**RM003 Penshurst Place Estate's objection to the Environment Agency's  
Application to vary the Scheme within the River Medway (Flood Relief) Act 1976**

**Environment Agency technical response, February 2021**

Figure 9: Increase in flood depth in a 1.33% flood event. 28.05m AOD vs 28.6m AOD

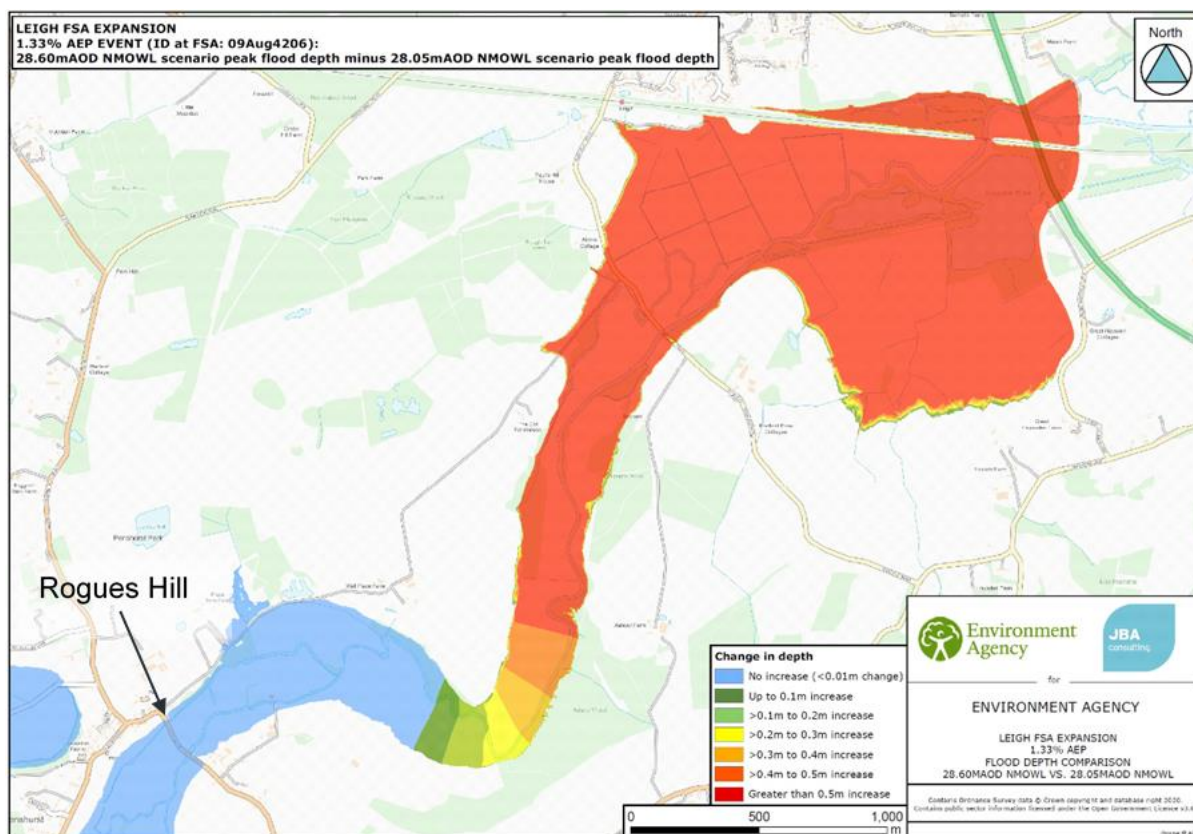
*At page 21 of the Application, the EA asserts that “the anticipated maximum flood water levels will not increase near Penshurst Place as a result of the Revised Scheme”.*

*However, this conclusion is inconsistent with Section 4.1 at page 23 of the Application which states that: “Modelling shows that the FSA adds approximately 0.1m in depth to the natural floodwater level to land around Penshurst.”*

*The EA's modelling that underpins its conclusion that the revised Scheme will not result in increased flooding at the Estate is based on an assessment of a 1 in 75 year event. This approach is inadequate and contrary to current flood risk assessment guidance and accepted best practice. WSP's view is that the Application should have properly assessed the 1 in 100 year plus 25% for climate change scenario. This is a requirement of the EA in respect of many planning applications where it is a statutory consultee. No explanation as been provided as to why this modelling has not been presented as part of the Application.*

As explained above and demonstrated in Figures 9, 10 and 11 above, there is no additional increase in flood depth at Penshurst if the maximum storage level is increased to 28.6m AOD.

In our Application to vary the Scheme for the operation of the Leigh FSA, the Environment Agency chose the scenario in Figure 9 to demonstrate the impact of expanding the FSA because it shows the greatest change in flood depths as a result of the proposed change. Figure 9 above shows a plan of the additional depth of water during a modelled 1.33% (1 in 75 year) flood event as a result of changing the maximum stored water level from 28.05m AOD to 28.6m AOD.

Figure 11: Increase in flood depth in a 1% plus climate change flood event. 28.05m AOD vs 28.6m AOD

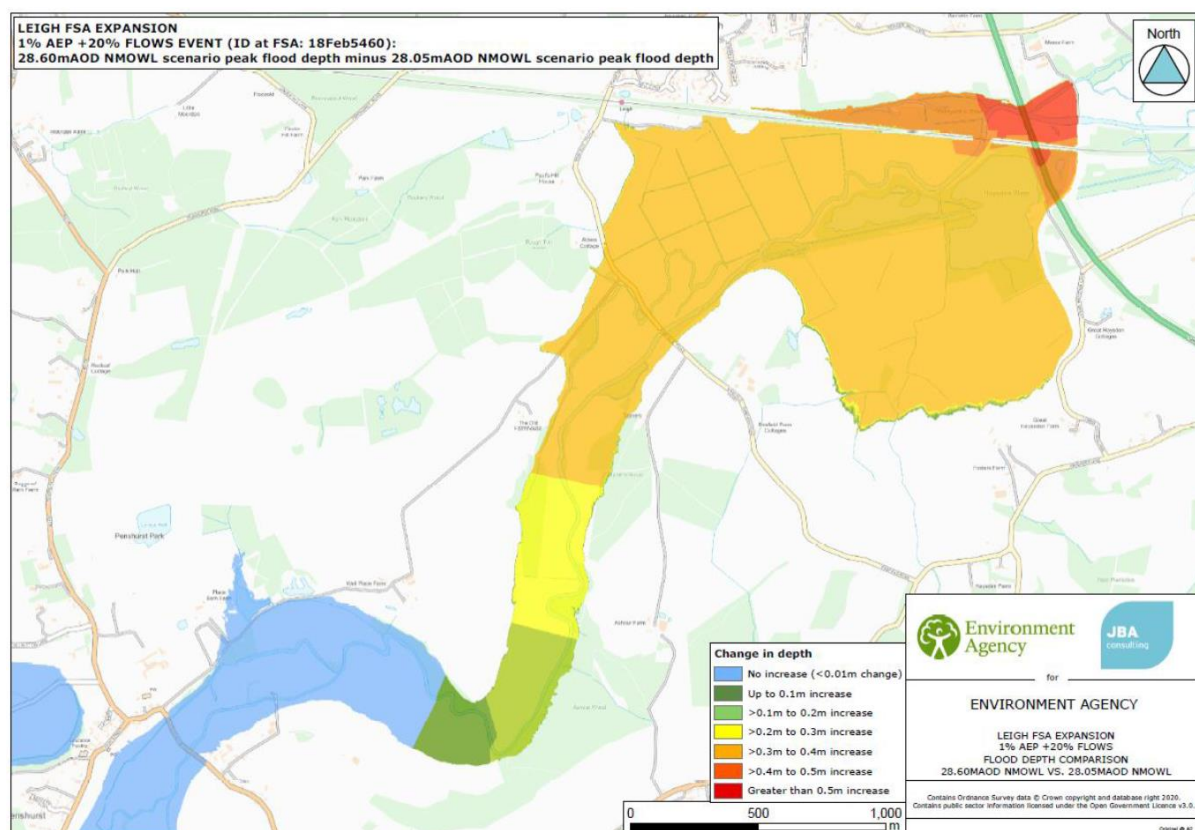
*As part of the discussions prior to the submission of Application, the EA's consultants did provide an assessment of the 1 in 100 year plus 25% for climate change scenario. A copy of this modelling is attached as Appendix B.*

*This assessment indicated that in this scenario there is likely to be an increase of 100mm in flood levels within the Estate, including at the Concrete Road. It also indicates that the Flood Storage Area will extend beyond its current boundaries within the Estate – i.e. more land within the Estate will be flooded as a result of the amended Scheme. Neither of these impacts has been properly acknowledged within the Application material.*

The Environment Agency has considered a wide range of flood events when considering the impact of expanding the FSA, including a 1% plus climate change scenario. These scenarios are included in the Flood Risk Assessment supporting our planning application, also see Figures 9, 10 and 11 above.

Also as explained above, when the FSA is operating, the proposal to increase the maximum stored water level from 28.05m AOD to 28.6m AOD may increase the maximum depth of flooding on land downstream of Ensfield Road by up to 0.55m. As shown on the plans in Figures 9, 10 and 11, the change to flood water levels diminishes as you move upstream from the control structure.

Figure 12: Locations of key ground elevations against which modelled flood levels are compared

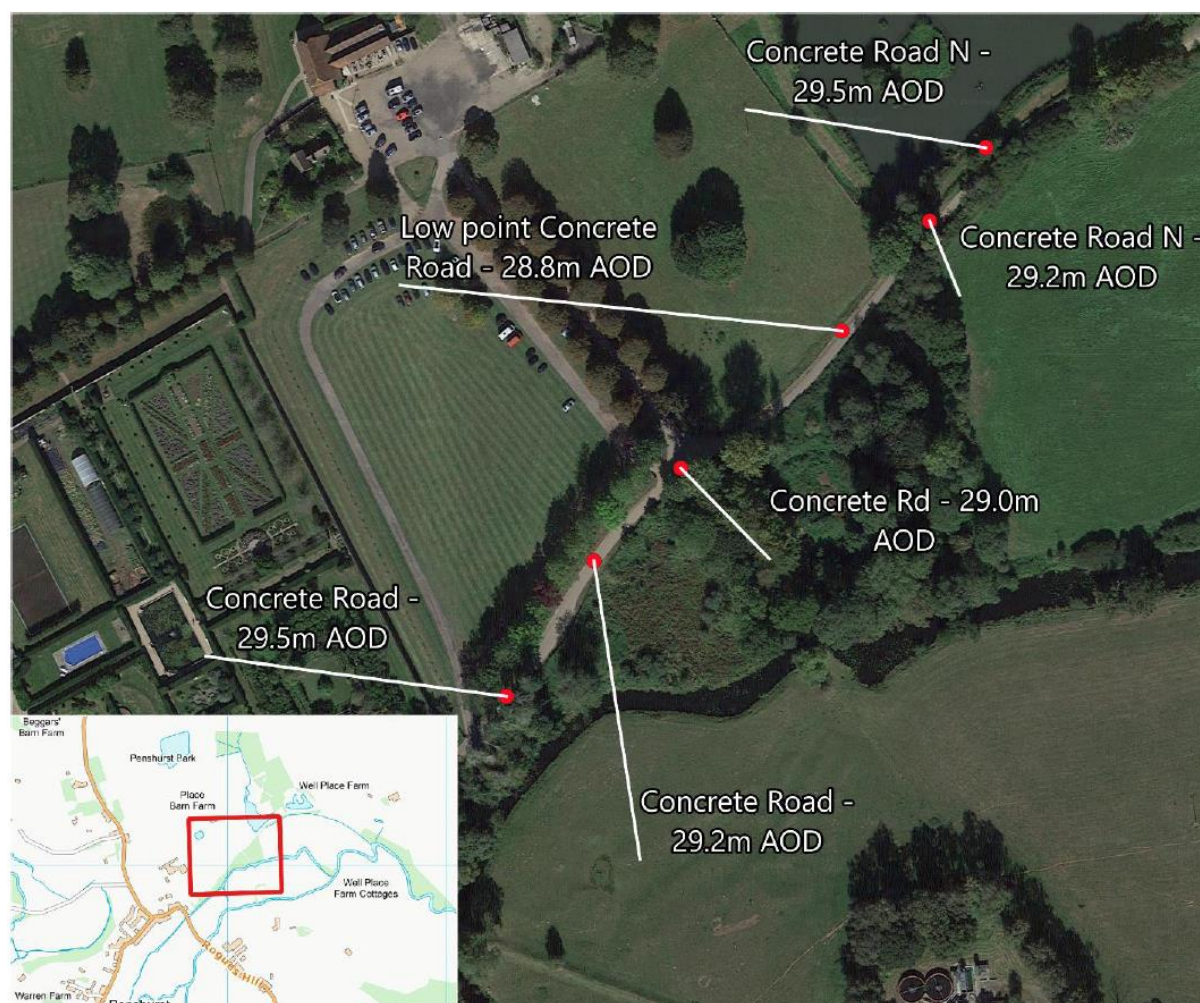
*There is a risk that the Concrete Road will be flooded during the 1 in 100 year plus climate change scenario by up to 100mm. The Concrete Road itself is already raised from the surrounding land. WSP consider there is a risk that water levels on the land immediately adjacent to the Concrete Road would increase by up to 600mm due to the relative difference in ground levels. The EA/Defra guidance on Flooding and Risk (FD2320/TR2) categorises flooding of 600mm as being a 'danger for most'.*

*There is a defined edge and drop between the Concrete Road and these areas which in circumstances where the Concrete Road is under water (and in particular where the edge of the road is under water) creates a considerable safety risk for drivers.*

*In practice the road may become impassable and large parts of the Estate, including the main visitor access, gift shop, nursery and several residential properties would become inaccessible.*

The other section that can be affected is near Place Barn Farm. The entrance into the visitors' car park (which provides access to the Gardens, Gift Shop, Café and Dairy Cottage), is approximately 29.5m AOD and the exit from that carpark is approximately 29.0m AOD. The low point along this section is approximately 28.8m AOD and is just beyond the exit from the carpark. The locations of these are shown in Figure 12, below.

With the lowest point of the Concrete Road near Place Barn Farm being at 28.8m AOD, the information presented in Table 1 identifies the following:

- The Concrete Road will flood as a result of natural flooding that is driven from high flows upstream during more severe flood events (events with approximately 2% or less chance of occurring in any one year).

- During an extreme 1% + climate change flood event (an event more severe than any experienced in living memory at the Concrete Road), there is potential for the operation of the FSA at 28.05m AOD (i.e. the existing maximum impounded water level) to increase the depth of flooding over the Concrete Road by up to 0.1m on top of the natural flood level (to 29.4m AOD). At this point in time the road would already be impassable because it would be flooded to a depth of approximately 0.5m (to 29.3m AOD) as a result of natural flooding from downstream flows.

- Increasing the maximum storage level of floodwater in the Leigh FSA from 28.05m AOD to 28.6m AOD will not increase the depth of flooding on the Concrete Road.

- Whilst the low point of the Concrete Road and the exit of the visitors' car park may be impassable due to flooding, the entrance to the visitors' car park (which is approximately 29.5m AOD) is unlikely to be flooded and therefore in these unusual circumstances could be used for egress and well as access. This would provide access to the Gardens, Gift Shop, café and Dairy Cottage all situated at Place Barn Farm. This is why in the Application (in 3.2 on page 22) we said that flooding of the Concrete Road only affects access to the residential and commercial households at Well Place Farm and Killick's Bank.
